Shearwater Petrel 1 & 2/Perdix/Perdix AI/NERD 2 Firmware v71 Release Notes

VERSION 71 2019.09.10

Shearwater Petrel 1 & 2/Perdix/Perdix AI/NERD 2 Firmware v65 Release Notes

Surface GF is the gradient factor if you were to instantly ascend to the surface

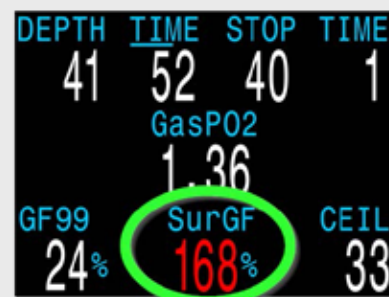
Surface GF display added. This shows the gradient factor if you were to surface immediately. This is different from GF99, which shows your gradient factor at the current depth. Is available:

- On the standard info screens (i.e. after a few right button presses).
- Can be configured on open main screen locations.
- Can be configured as the NDL replacement (appears in-place of NDL once deco is needed)

Log Rate can be set to 2, 5, or 10 seconds

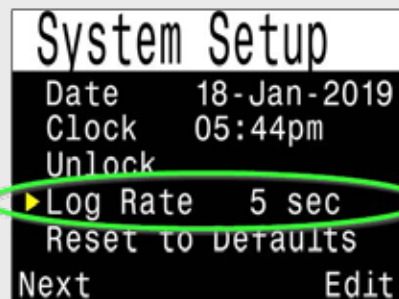
Log sampling rate can be set to 2, 5, or 10 seconds (previously always 10 seconds). Note that log downloads may take longer with faster sampling rates as more data is being recorded. Also, less logs can be stored until they are overwritten. For example, about 1000 hours are stored at a 10 second rate, but only 200 hours at a 2 second rate.

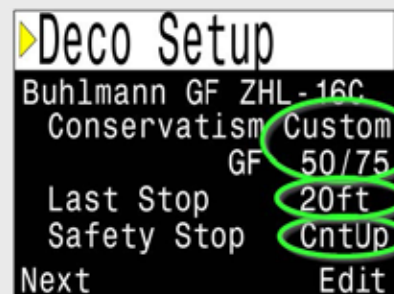
Allows user to select a 20ft/6m last stop depth in OC Rec mode. Previously the last stop was always 10ft/3m in OC Rec mode.

The “Clear Counter” counts up once deco is clear

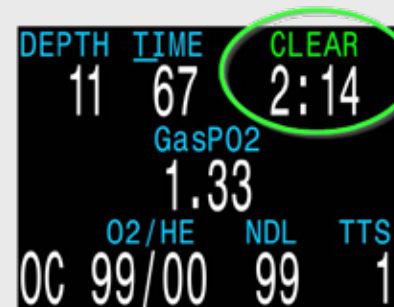
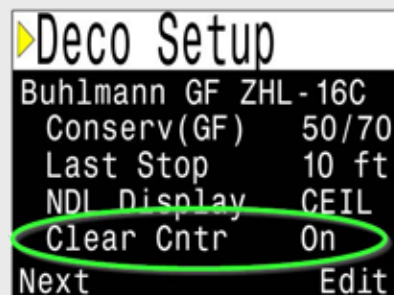
A “Deco Clear” up-counter option has been added.

Available in OC Tec, CC/BO, and OC Rec modes. In OC Rec mode it is available in place of the safety stop. Optional in Tec modes.

When deco clears this counter begins counting up from 0. It is useful for timing additional padding after the mandatory decompression stops. If the dive did not need deco, then begins upon entering the safety stop zone (i.e. shallower than 20ft / 6m).

The “OC MOD PPO2” replaces “OC Max PPO2” with different behaviour. Please read the description to left!

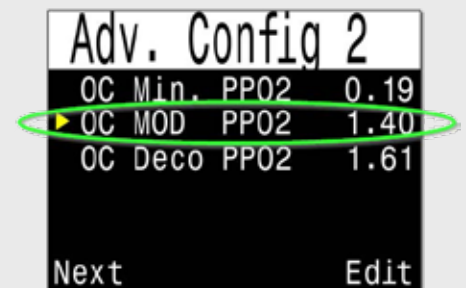
Previously, there was an “OC Max PPO2” setting which only defined when the “High PPO2” message occurred, regardless of dive phase (e.g. bottom depth or at deco stop). This confused many users who, quite reasonably, assumed it was the “bottom depth” limit and set it to 1.40. This would result in warnings during deco when the PPO2 was pushed to the 1.60 range.

The “OC Max PPO2” has now been removed and replaced with a “OC MOD PPO2” setting. The MOD setting only applies to the bottom depth phase. The dive computer automatically switches to using the “OC Deco PPO2” limit when within 2 stops of the next deco stop. The “OC Deco PPO2” limit also sets where predictive deco gas switches occur. Also, if the current gas has greater than or equal to 80% oxygen fraction, then the deco limit is used, as the gas is assumed to be a deco gas.

After updating, the “OC MOD PPO2” value is set to 1.40 ATA and the “OC Deco PPO2” is unchanged. Defaults are:

OC MOD PPO2 = 1.40 [ATA]
OC Deco PPO2 = 1.61 [ATA]

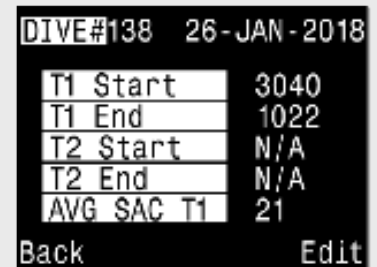
The in-computer dive log now displays start and end tank pressures and average SAC.

The tissues bar graph is now shown on the Tissues Restored screen

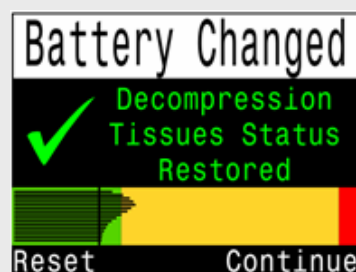
NEW After changing the battery, the current deco tissue loading is shown on the Tissues Restored screen.

NEW On the Tissues Restored screen, a shortcut to reset the tissues is given. If Reset is chosen, a prompt will be displayed to confirm. **Do NOT reset tissues between repetitive dives, as inert gas loading will be lost.**

The offset between current and marked heading is now shown (in this example 16°)

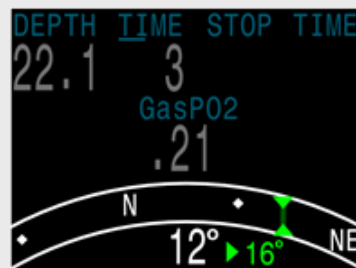
IMPROVE When a heading is marked, the display now shows the offset angle between the current heading and the marked heading. This is useful for navigating patterns. For example, a box pattern requires turns at 90° intervals, while a triangle pattern requires turns at 120° intervals.

On the “Bus Devices” page, choose “View” to see more info and settings

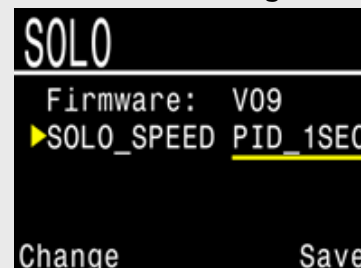
For example, on the SOLO board (solenoid and oxygen controller) the Solenoid Speed setting can be adjusted. Go to “Bus Devices” page on Petrel to access peripheral boards. Settings viewed here are stored on the peripheral device.

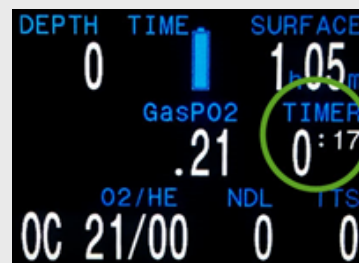
The current compass numerical value (azimuth) is shown on the “Mark Heading” menu.
